Request for review for: "Jiratpattana Biogas Energy Project" (2144): Response from the Project Participants

Figure 1: Thai Baht to US Dollar exchange rates from July 1995 – July 2005 (Source: Bloomberg Finance LP)

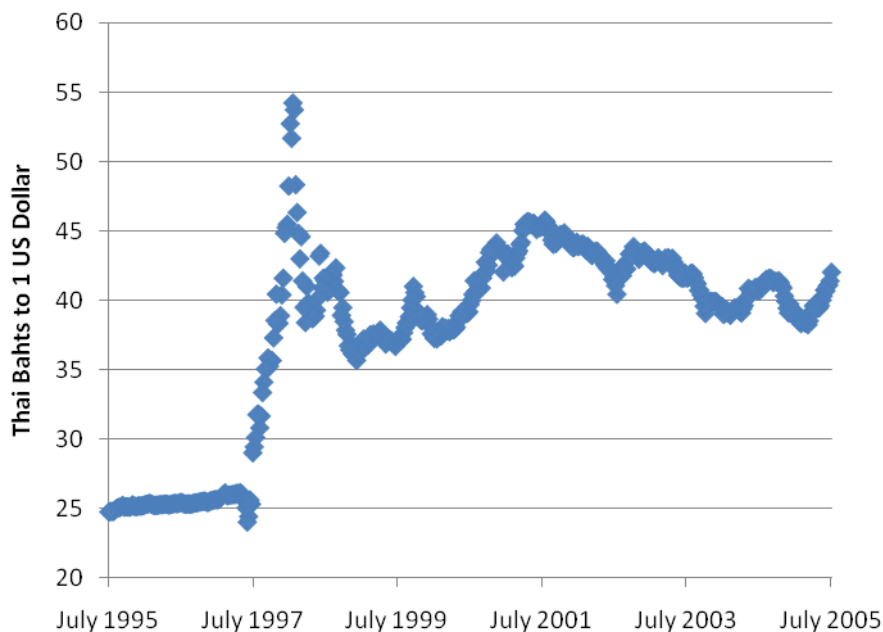
The technology used in the project has been imported into Thailand, and the evidence for this (list of equipment from the technology provider) is referenced in the validation report. This equipment was paid for in US Dollars, whilst in the absence of CDM the project would have no income in US Dollars, only in Thai Baht, the local currency. This would mean that there would be a significant exchange rate risk, which exacerbated the low rate of return and made the project even more unattractive for investors. Exchange rate fluctuations can be seen in figure 1 of this response, which shows the Thai Baht exchange rate for the 10 years prior to decision making. This figure clearly shows that there have been large fluctuations in the exchange rate, particularly following the 1997 Asian financial crisis, that significantly increase the risk of financing such a project for potential investors. Carbon credit sales are paid for in US Dollars, so the CDM effectively mitigates the exchange rate risk.
